PART 3A MAJOR PROJECT APPLICATION SUBMISSION BY KU-RING-GAI COUNCIL

SUMMARY SHEET

PROPOSAL:	132 - 138 Killeaton Street, St Ives – Erection of 5 x 5 storey residential flat buildings containing 298 units, basement carparking, adaptive re-use of existing monastery building for communal facilities, landscape works, strata subdivision and staged construction/occupation
WARD:	St Ives
APPLICATION N^o:	MP 10_0057
SUBJECT LAND:	132 to 138 Killeaton Street, St Ives
APPLICANT:	Karimbla Properties (No.4) Pty Ltd – Meriton
OWNER:	Dasmin Pty Ltd
DESIGNER:	Meriton Apartments Pty Ltd
PRESENT USE:	Vacant, former monastery building
ZONING:	R4 Residential
HERITAGE:	No
PERMISSIBLE UNDER:	Ku-ring-gai LEP (Town Centres) 2010
COUNCIL'S POLICIES APPLICABLE:	Ku-ring-gai LEP (Town Centres) 2010 Ku-ring-gai DCP (Town Centres) 2010 Ku-ring-gai Section 94 – Development Contribution Plan 2004 – 2009 Residential Development (Amendment 2) Ku-ring-gai Town Centres Development Contributions Plan 2008
GOVERNMENT POLICIES APPLICABLE:	NSW State Plan 2010 Draft North Subregional Strategy Metropolitan transport Plan 2010, Integrating Land Use and Transport – A Planning Policy Package 2001 and Planning Guidelines for

Figure 1: Site layout showing Block A, B, C (fronting Killeaton Street), the existing monastery building to the centre and Block D and E to the rear of the site.

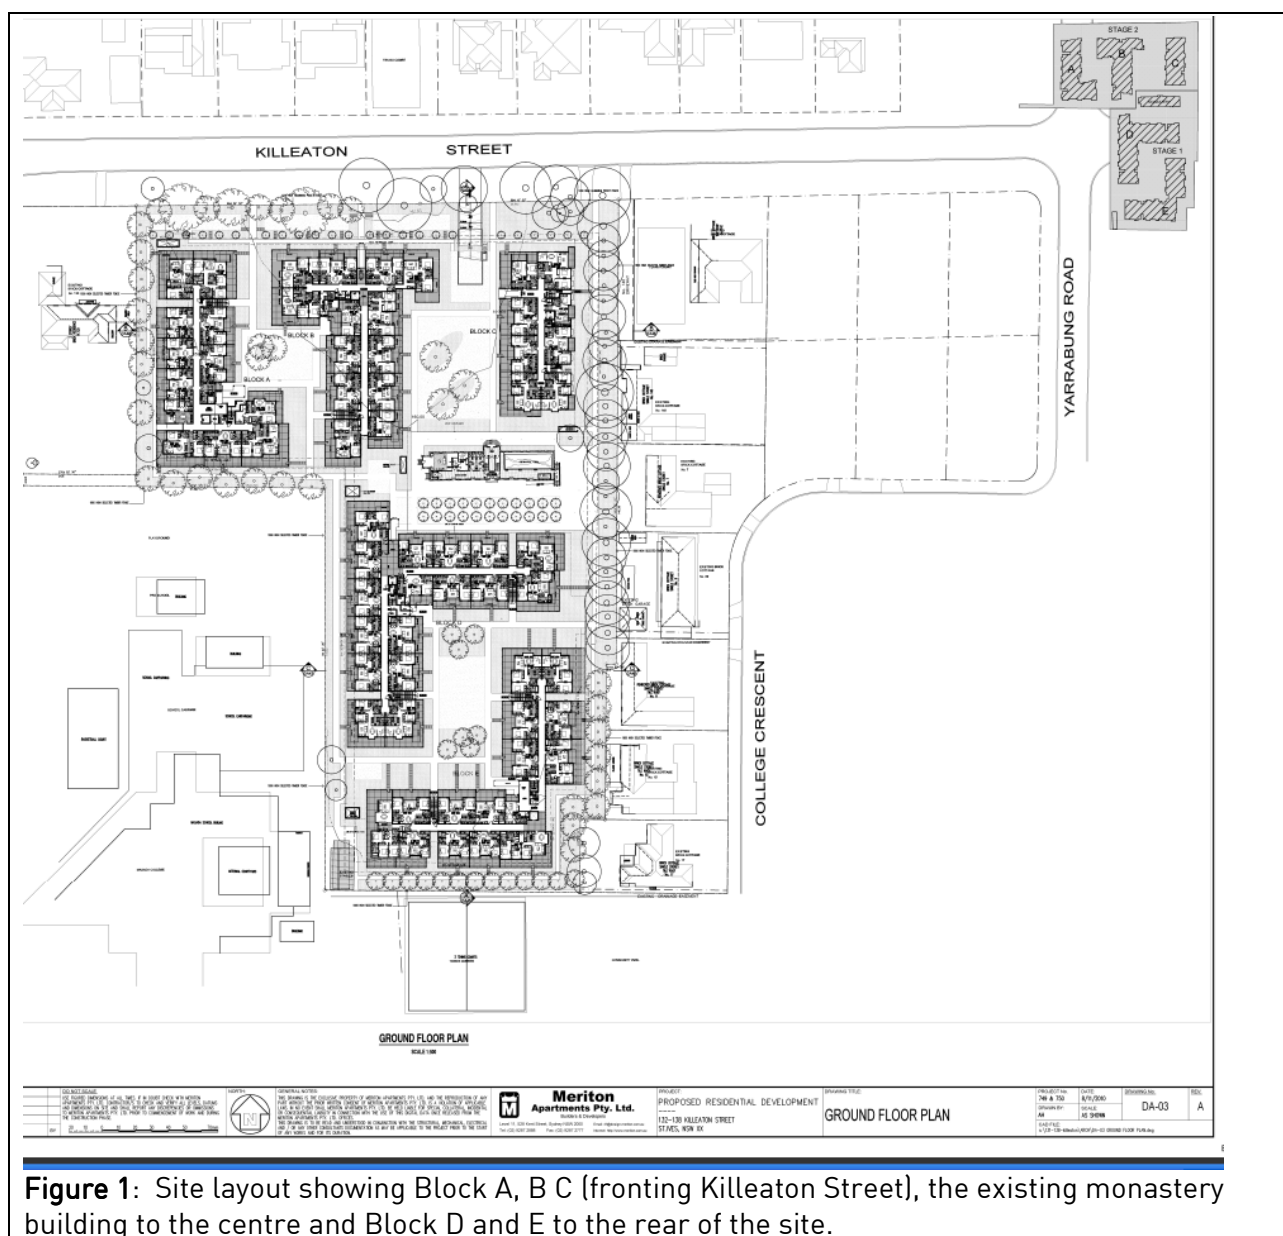
The surrounding context is dominated by large open institution and education premises which are characterised by generous landscaped setting and low scale built forms (see Figure 1 for context). The development site has a considerable street frontage to Killeaton Street which is a local residential street with single dwelling character. There are single dwelling lots directly adjoining the eastern boundary of the site with major interface impacts. Note that these lots have been up-zoned to *R3- Medium Residential Density* to allow townhouse developments up to 3 storeys

- The site layout, of having three separate buildings on north-south axis fronting Killeaton Street, is supported as it responds to the existing context of object buildings set within a landscaped setting. However it is recommended to amend the following:
 - o Delete the east and west 'wings' of Building B to create shorter, smaller building frontage to the street, thereby reducing its perceived bulk as well as improving view corridors to the monastery building and Masada College site;
 - o Delete the east 'wing' of Building A to further enhance the visual link to the Masada site, taking advantage of landscaped backdrop formed by the well-established tree canopy when viewed from Killeaton Street;
 - o Shorten the southern end of Building B to facilitate views to monastery building from the north-west corner of the site.

Proposed Building B & C are planned to create a common open area in front of the monastery building allowing a partial view of it from the street. The eastern units to Building B intrude into the view corridor. The car entry is also located in the middle of the open space between Building B and C. It would be a benefit to delete the eastern units to Building B and relocate the vehicular entry under building B to improve the relationship of this space to the street and to maintain views of the building.

Figure 4: Recommended new site configuration.

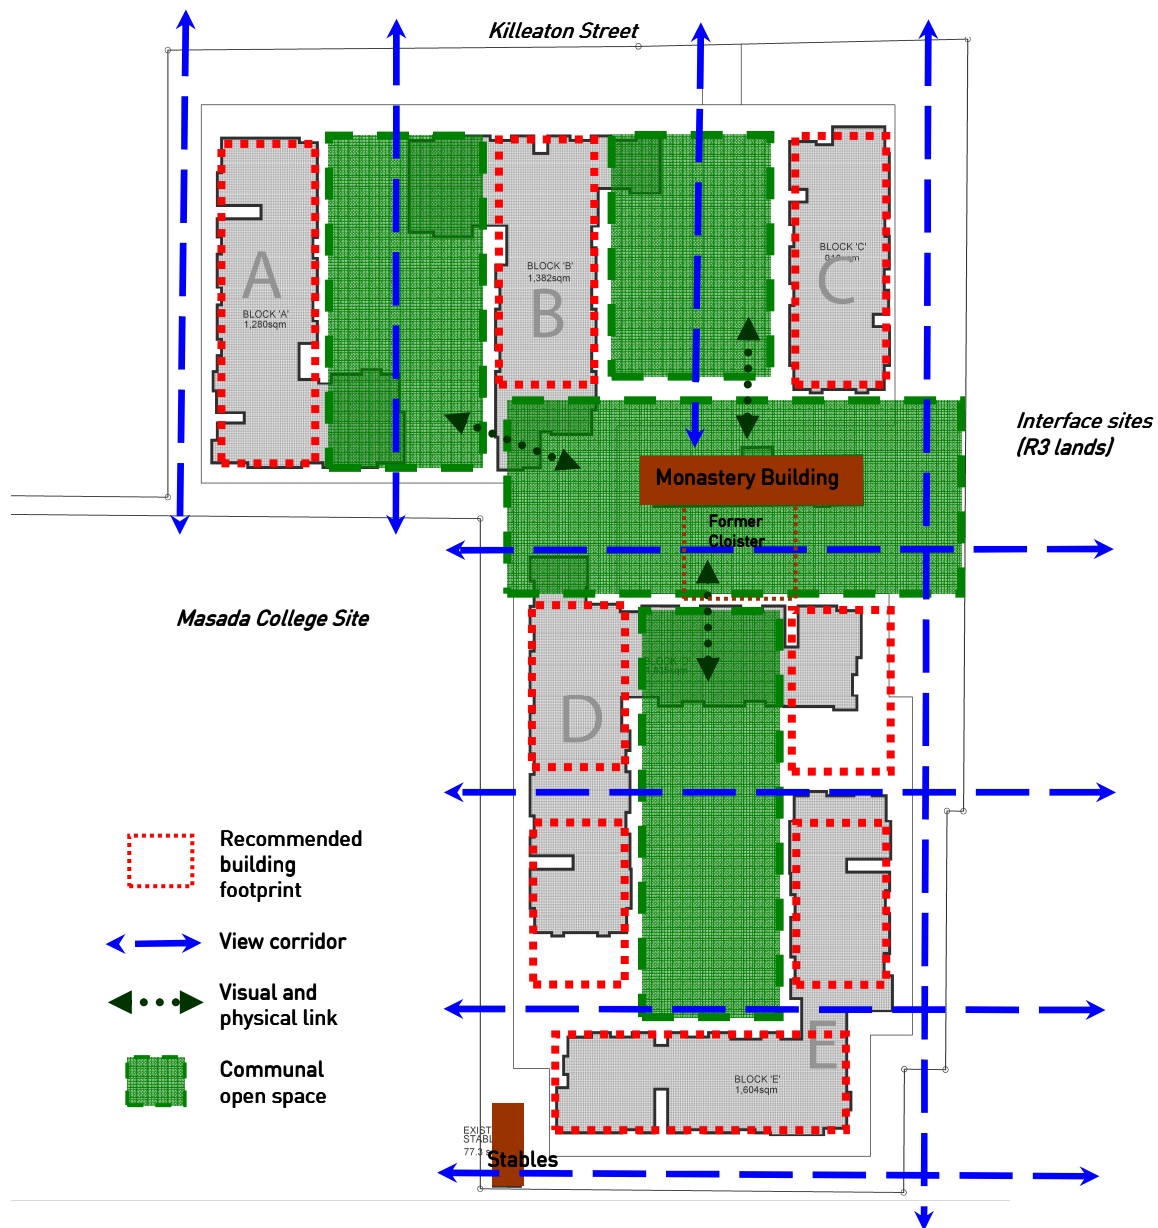
The key recommended amendments to the proposed site configuration are illustrated in Figure 4 and summarised below:

- The buildings on the southern part of the site should be re-arranged based on the same site planning concept applied to the northern part, having object buildings set within a landscaped setting, with particular regards to visual impact and view corridors. Accordingly, the east-west 'wing' of Building D is to be deleted and re-positioned to:
 - o eliminate the looming wall effect which would have been created by the proposed building which is to be positioned very closely behind the monastery building;

- o provide additional open space to the rear the monastery building to avoid intrusion into the former 'cloister' space;
 - o facilitate views to Monastery Building from the southern part of the site;
 - o reduce number of south-facing apartments;
 - o improve internal floor layout; and
 - o minimise overshadowing impact on the southern communal open space.
- Building E is to be broken up to allow east-west corridor through the site. This may also result in a better internal plan layout compared to original L-shaped building.

Figure 5: Section of Building C showing top floor setback.

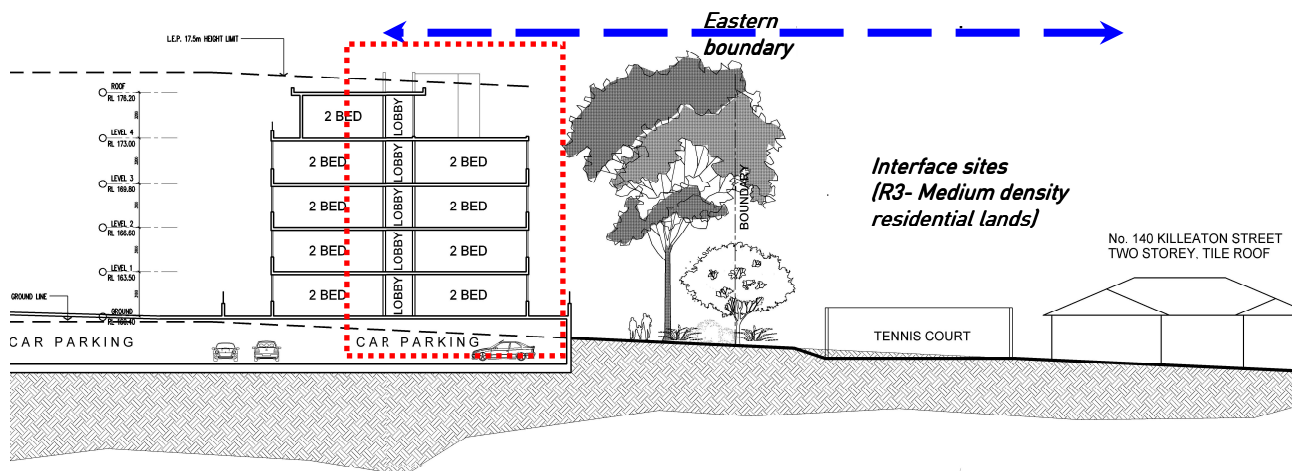
The scheme proposes the retention of a row of significant screen planting as well as increased tree planting along the eastern boundary of the site where it adjoins R3 lands currently occupied by single dwellings, providing effective visual buffer between properties. A building setback of at least 9m to the eastern boundary is provided to ensure adequate separation with adjoining properties. In particular, the top floor (ie. 5th floor) is proposed to be effectively set back from the perimeter walls, resulting in a built form that appears to be only four storeys in height when viewed from the east (single dwelling area). Refer to section in Figure 5 below.

It is recommended to consider the following measures to further alleviate the interface impacts:

- The incorporation of planter boxes on the edges of the terraces/balconies facing the eastern boundary would help enhance visual privacy.

Figure 6: Recommended new building setback line to the eastern boundary.

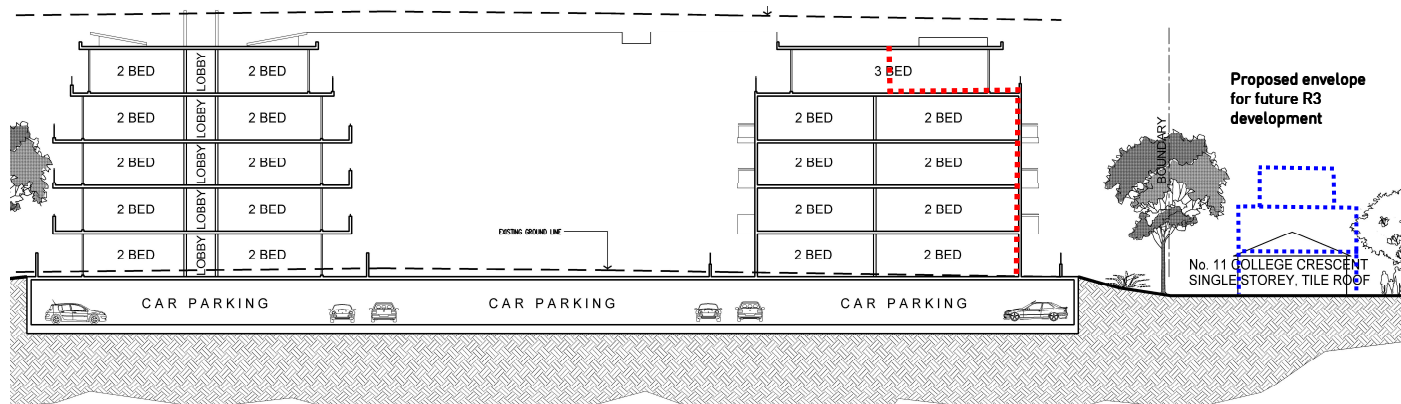
- The proposed buildings along the eastern boundary (on the southern part of the site) are to have similar setback treatment to the top floor as shown in Figure 5 to reduce the amenity impacts, while providing transition of scale to the future R3 developments (ie. townhouses) on adjoining sites. This can be achieved by removing a few east-facing apartments on the 5th floor. Refer to Figure 6 below for amended building setback line as shown in red dotted line.
